Meeting minutes from VE discussion at CERN 29-Jan-2019

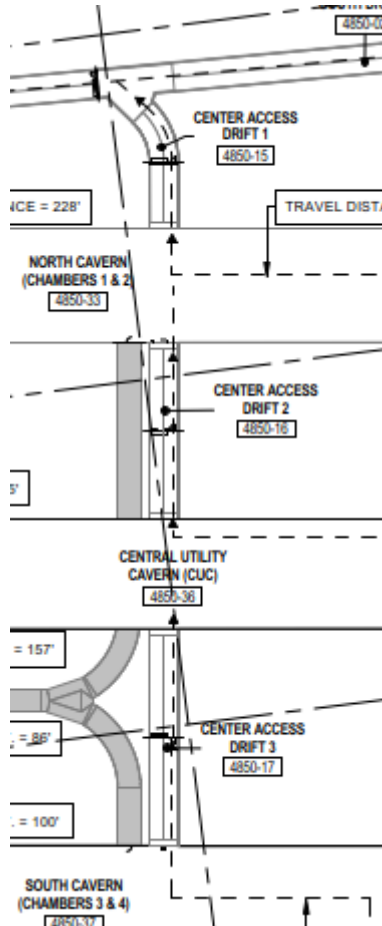
- N/S Access Drifts
 - Drifts 4850-16 and 17 can be reduced by some amount. Can we propose a reduction of 1 m? We should consider the material that may be moved through 4850-15 before reducing this as materials have to travel around the curve before entering the North cavern. I've included an image below to identify the drifts in question.
